651S-1
GENERAL PURPOSE HF RECEIVER

PUB NO.	NOTE	DATE	SUBJECT
IB 1-72 ✓		03/01/72	Subassembly Interchangeability
SB 1		10/01/72	Reduction of 450-kHz Leakage From Synthesizer Reference Board All
SB 2		06/06/73	Reduction of Noise Level
SB 3		07/15/73	Add Keep-Alive Frequency Memory Function
SB 4		07/15/73	Extend Comma and Decimal Lamp Life in Frequency Display
SB A ✓		11/01/73	Change DCFE Filter Switching Diode
SB 5	1	12/15/74	Minimize TCU Circuit Card Response to Data Link Noise and Failure
SB 6	2	03/01/75	Reduce Intermodulation Level
SB 7		02/07/75	Reduce Internal Spurious Signals
SB 8		12/27/74	Allow Remote Control Operation With RS-232C Serial Control Interface Card A9
SB 9 ✓		02/15/75	Increase Life of Display Tubes
SB 10 ✓	2	12/31/75 Revised 08/02/76, 04/01/77	Replacing Display Tubes With LED Plug-in Assemblies
SB 11		Not issued	
SB B ✓		11/15/74	KAV
SB C ✓		01/15/78	Supply KAV Power to DCFE
SB 12 ✓		05/01/78 Revised 07/01/78	Replacing Nonprocurable Integrated Circuits

SERVICE BULLETIN A

SUBJECT: Change DCFE Filter Switching Diode

651S-1/1 () Chassis, Partial Bottom View
Figure 1

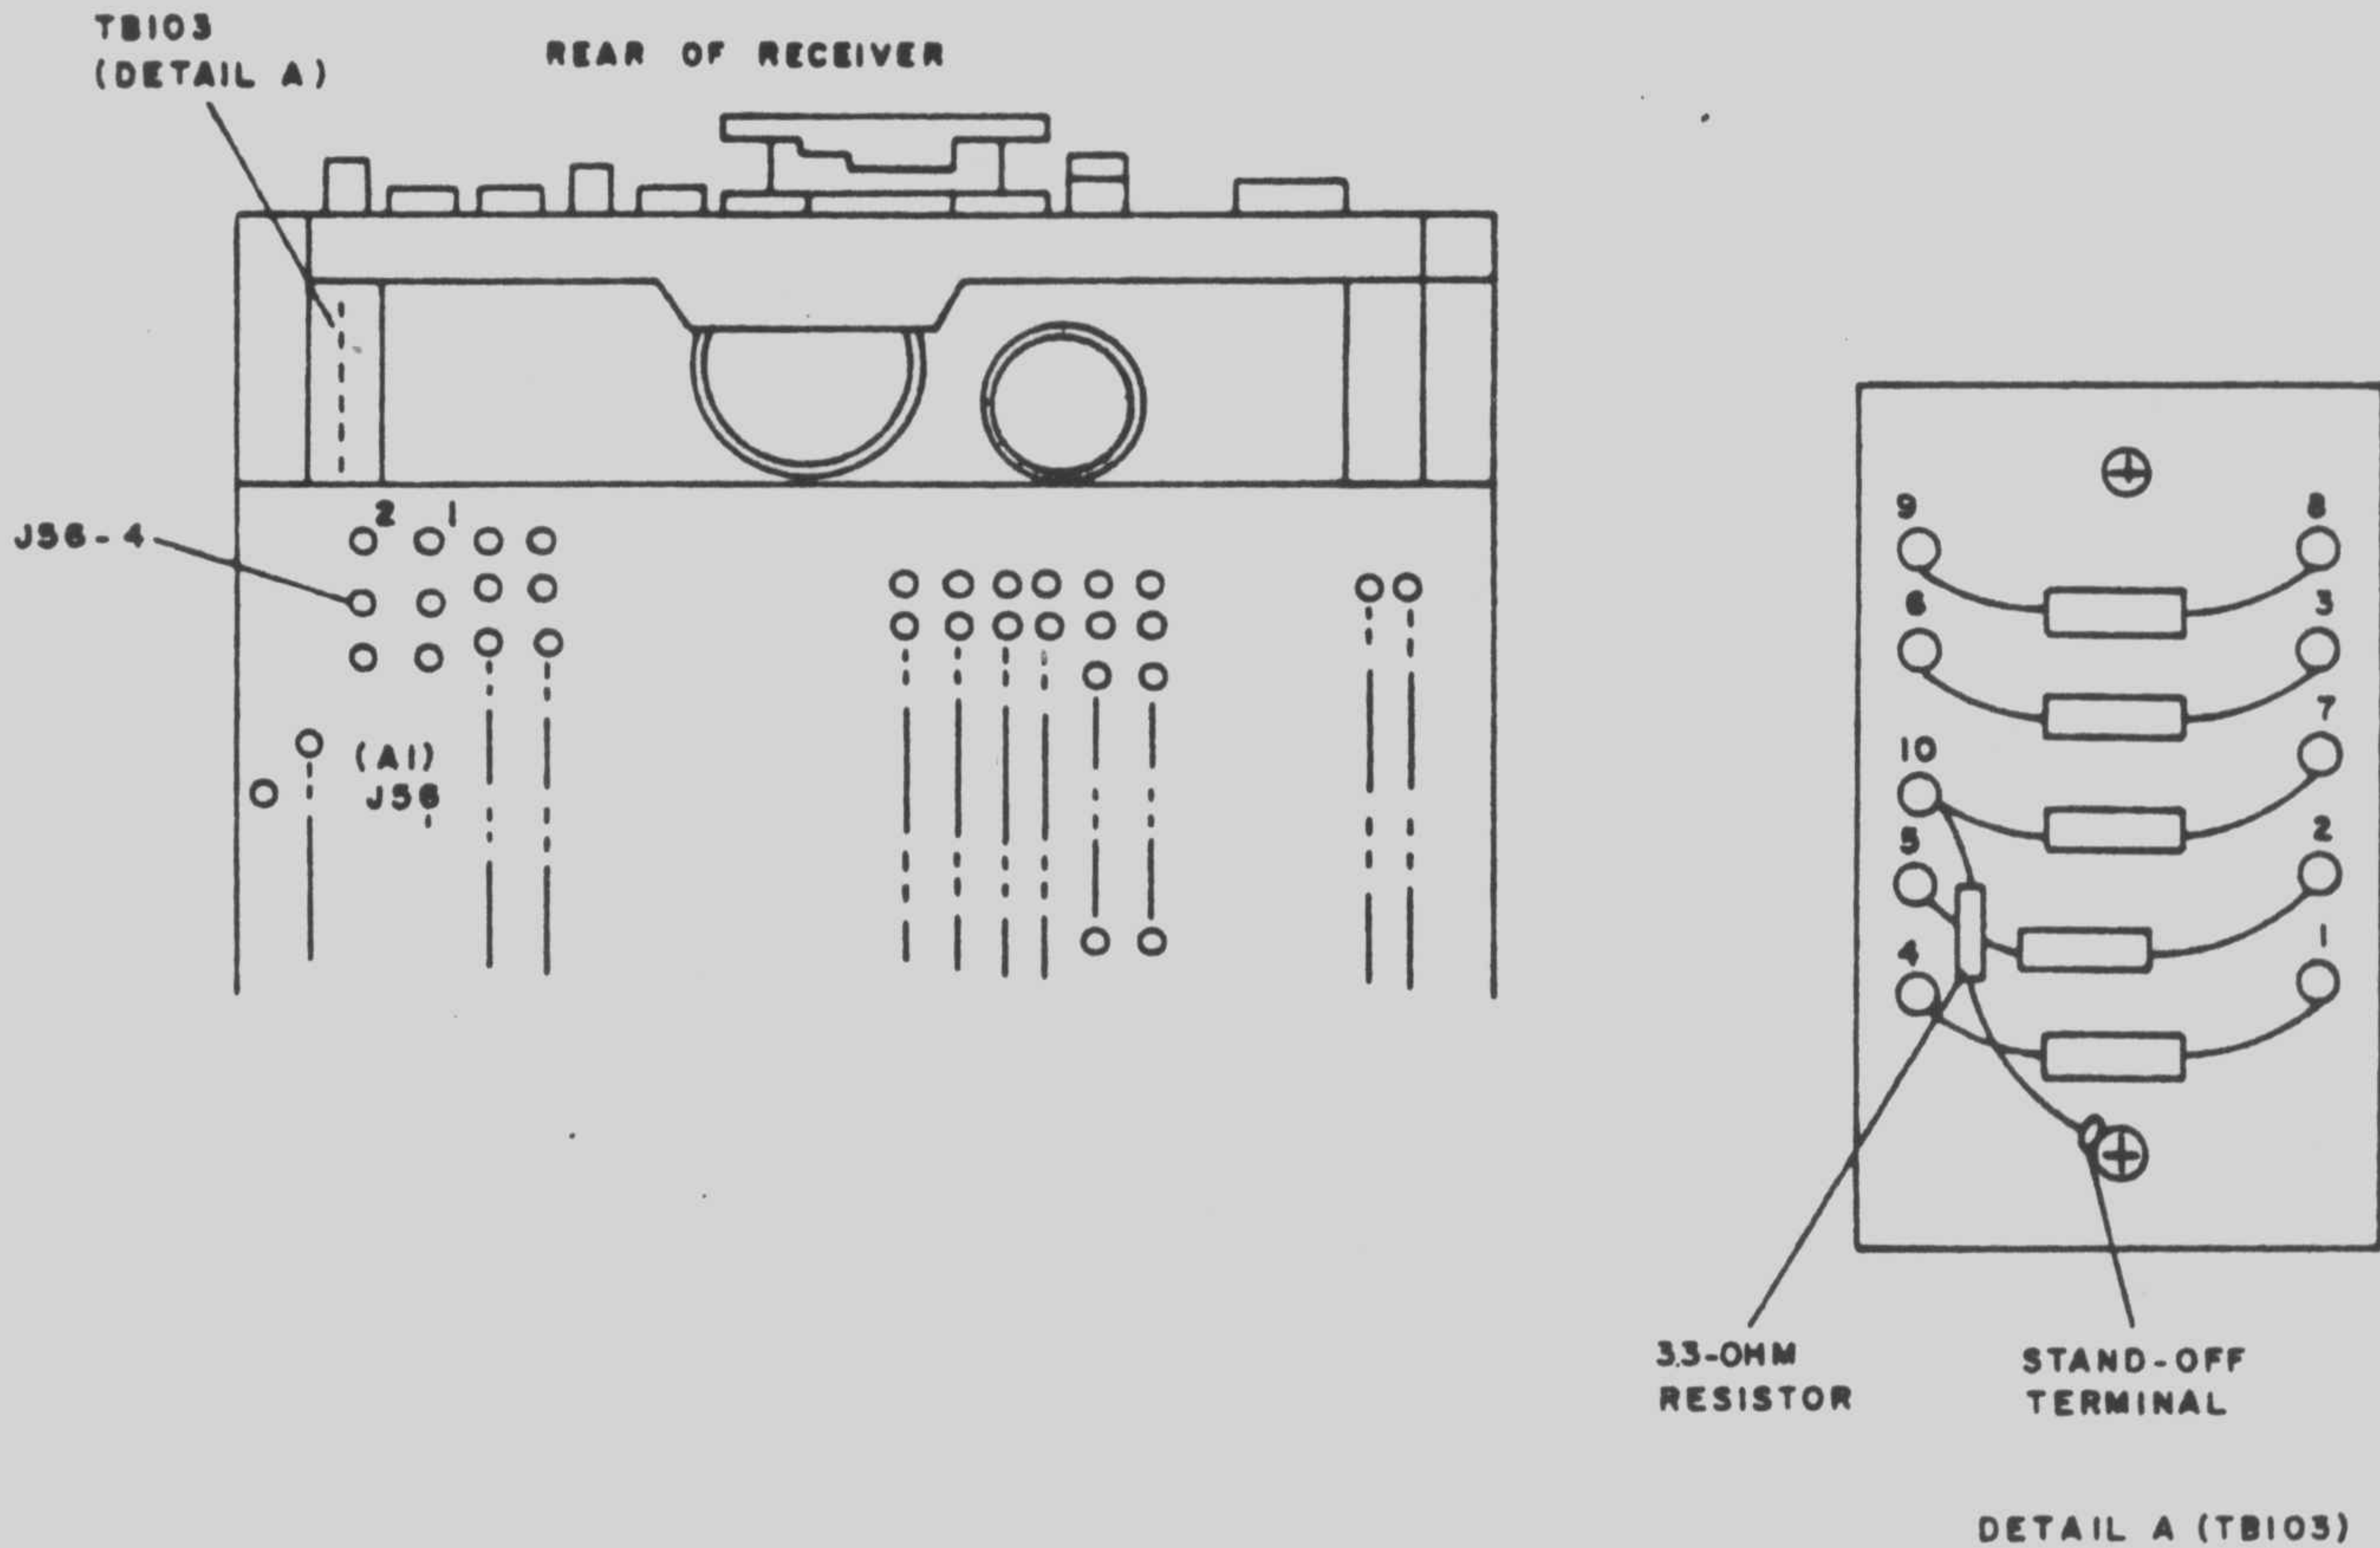
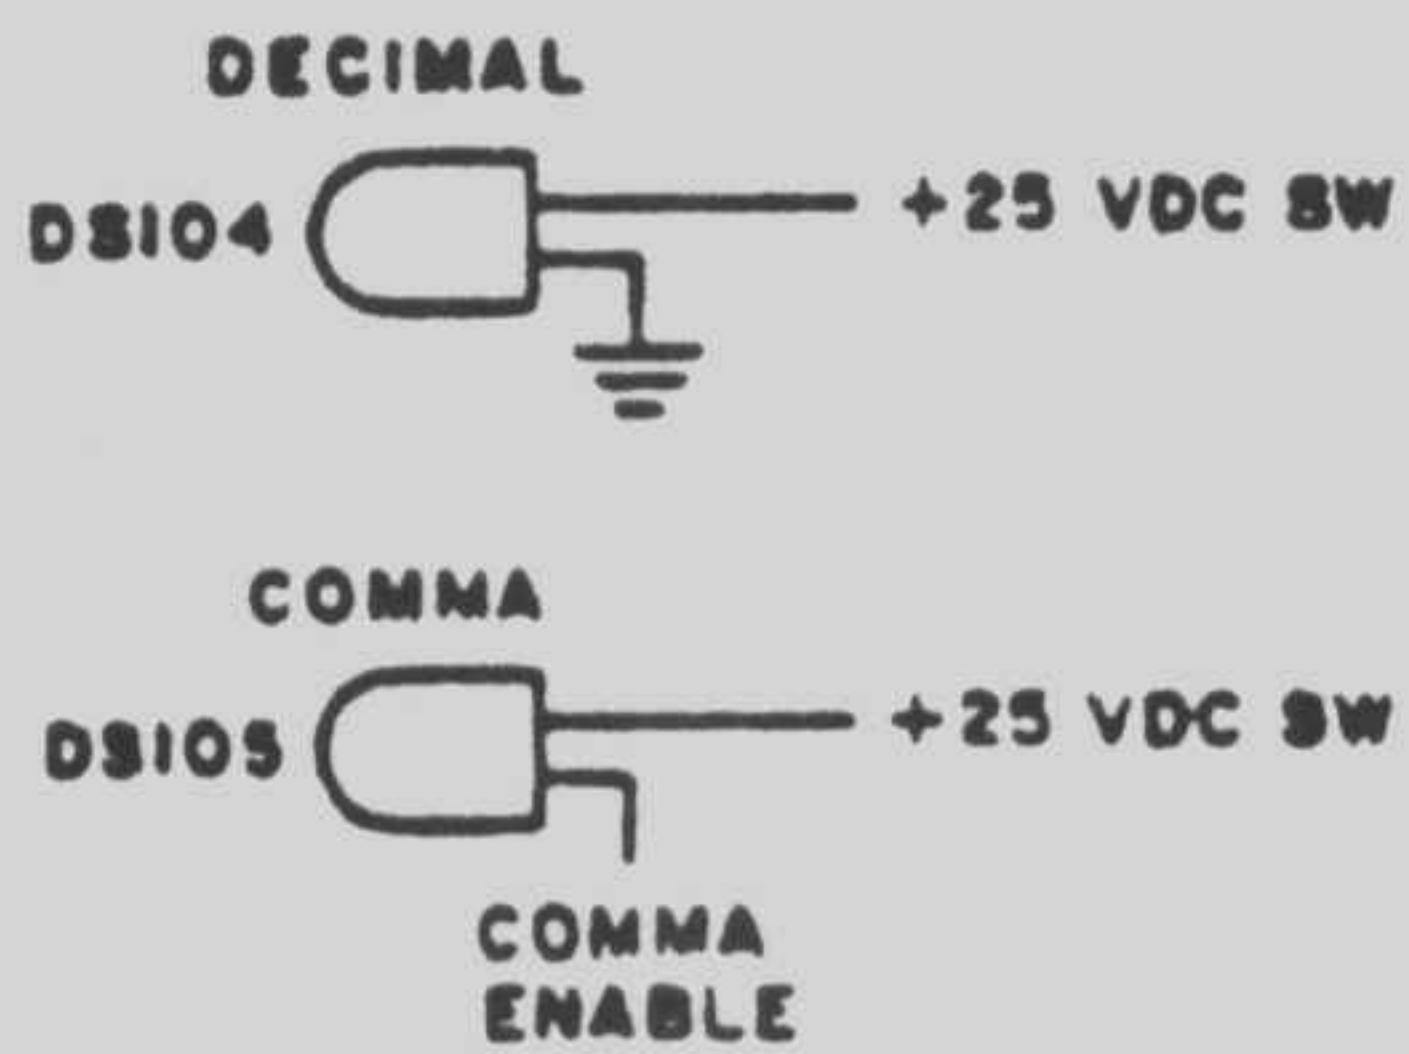
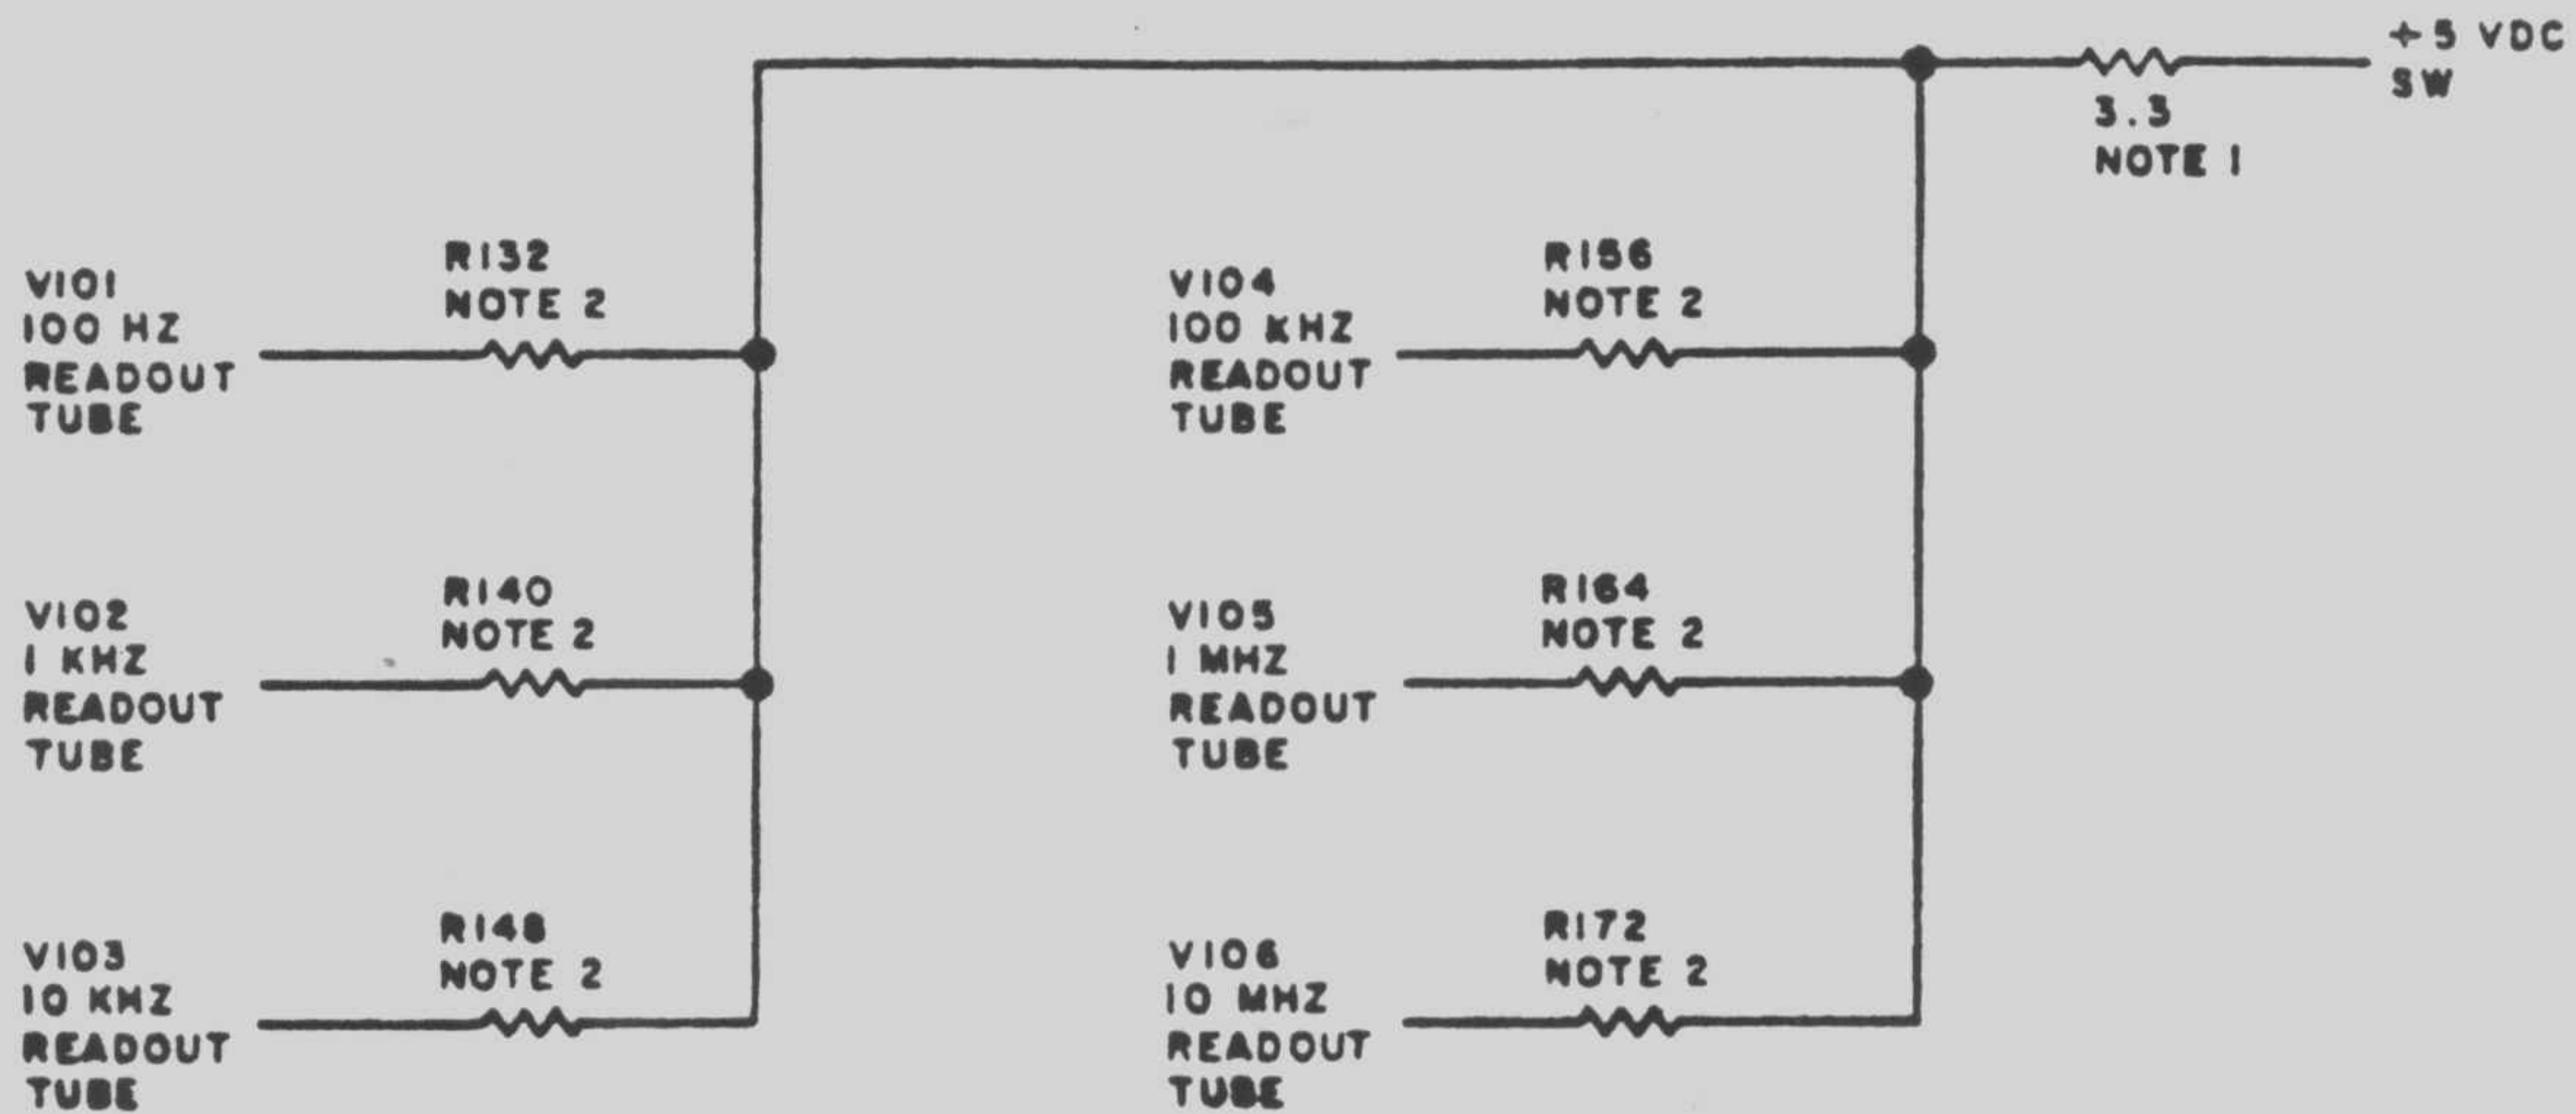
- S. Replace all knobs on the front panel.
- T. Perform the following procedures if the unit is modified by 651S-1/1A Service Bulletin No 9.
 - (1) Refer to figure 1. Unsolder blue wire connected on one standoff terminal on TB103 and connect and solder to J56-4.

- (2) Unsolder and discard the 3.3-ohm resistor.
- U. Mount the front panel assembly to the main chassis and secure with four screws on each of the two tie (side) plates (39, PL figure 1).
